**CITY OF DOVER, DELAWARE
PLANNING COMMISSION
Monday, March 17, 2025 at 7:00 PM**

AGENDA

6. C-25-03 New Harvest Baptist Church at 1462 N. Little Creek Road – Public Hearing and Review of a Conditional Use Site Plan for a Place of Worship (Church) building of 11,900 SF and related site improvements. The subject property is zoned RG-2 (General Residence Zone).

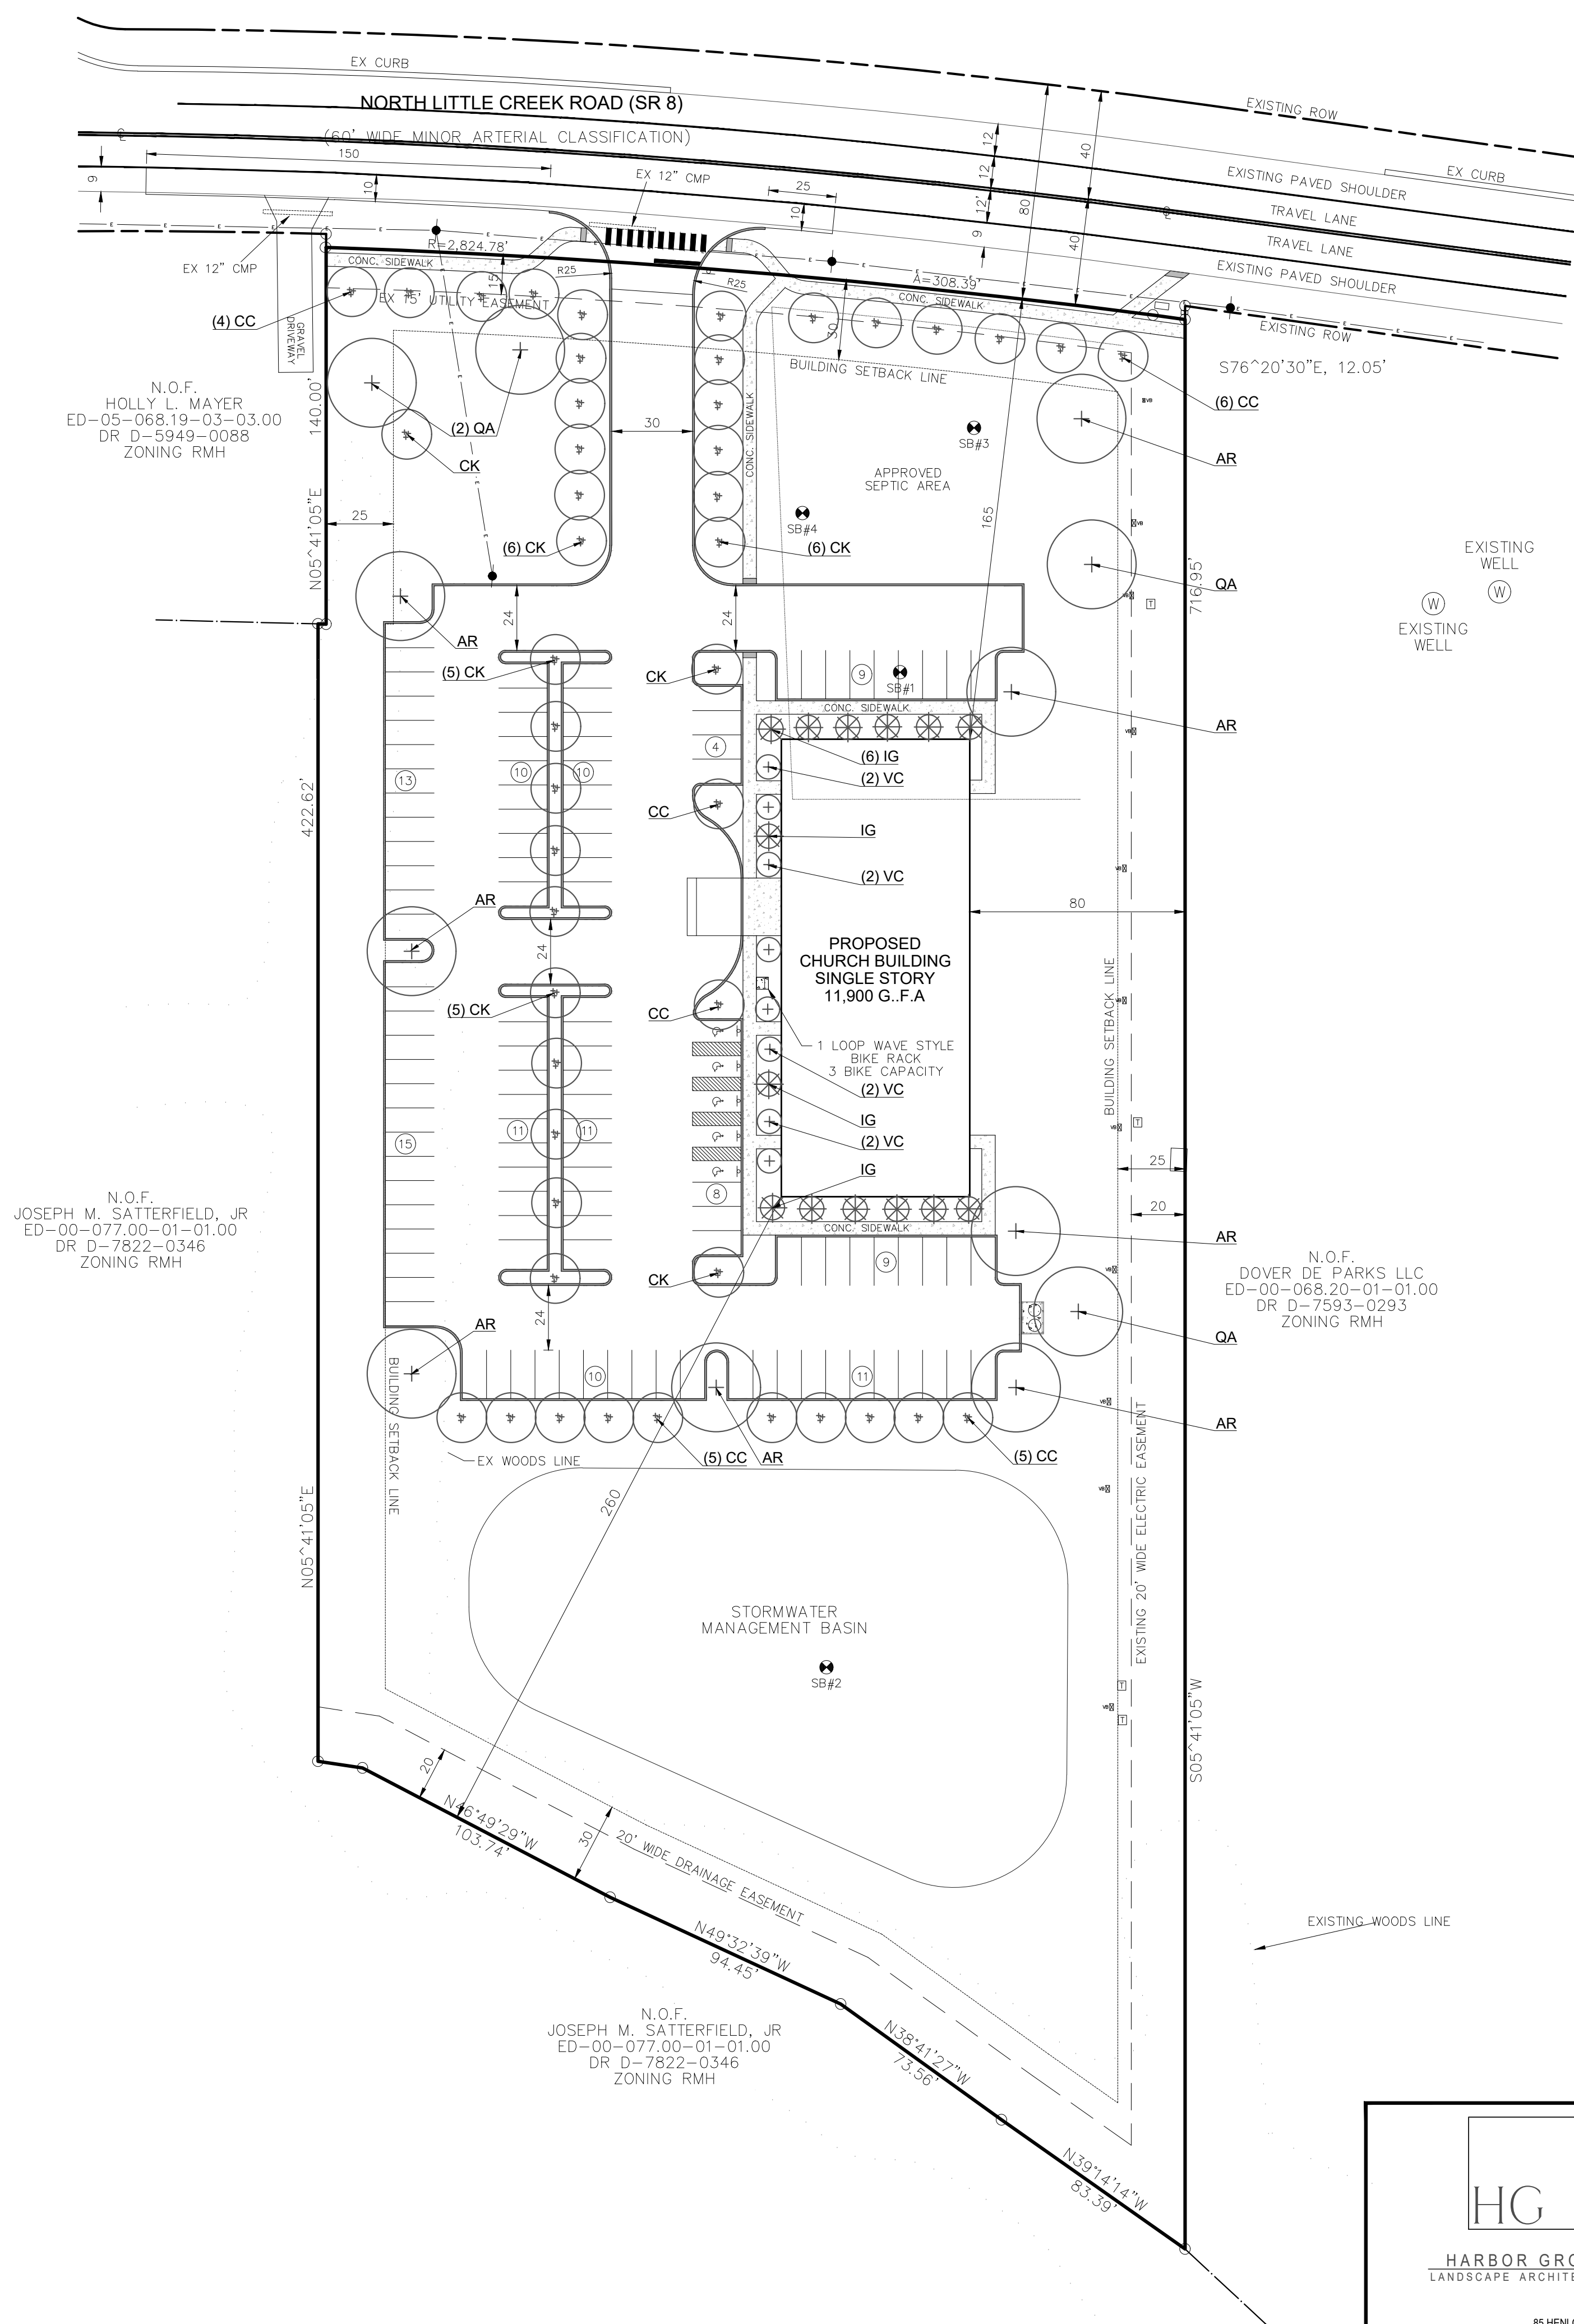
4) Sheets LS-1 and LS-2 Landscape Plan:

- a) Please correct the sheet number in the lower right corner to LS-1.
- b) Please show on the plan drawing the existing woodland delineation, the woodland proposed for clearing in accordance with Article 5, Section 16.81, and woodland areas to remain.
- c) The development area acreage of 203,252 SF is used for the tree density calculation. On the other plan sheets, the lot area is listed as 203,366 SF. Please confirm which is correct and correct the incorrect number.
- d) On Sheet LS-2, please include a detail and plan to protect preserved woodland area from sedimentation intrusion and erosion.

Figure 1: Tiles F3 and F4 of the Rail Land Use Corridor Study. The McKee Road Apartments parcel is in the center (shaded polygon), and it is adjacent to the active railroad (dotted line). Source: Kent County Rail & Freight Study - Interactive Map.

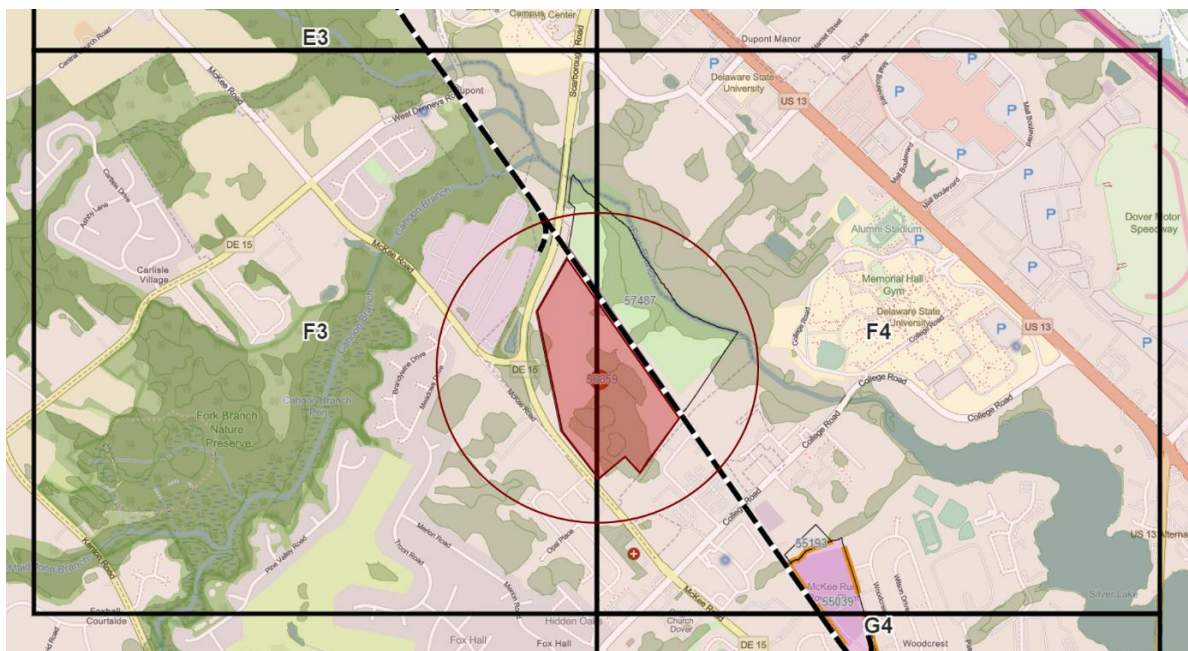
Dover Kent MPO maintains the opinion that the property should not be used for residential purposes. However, if residential units are to be constructed as currently planned, the site plan should be significantly revised to mitigate conflicting uses. A **wider buffer** should be used to distance the residential units from the railroad tracks. (The 2018 *Rail Zoning Study* noted that a buffer of at least 150 feet is recommended in much of the existing literature). The
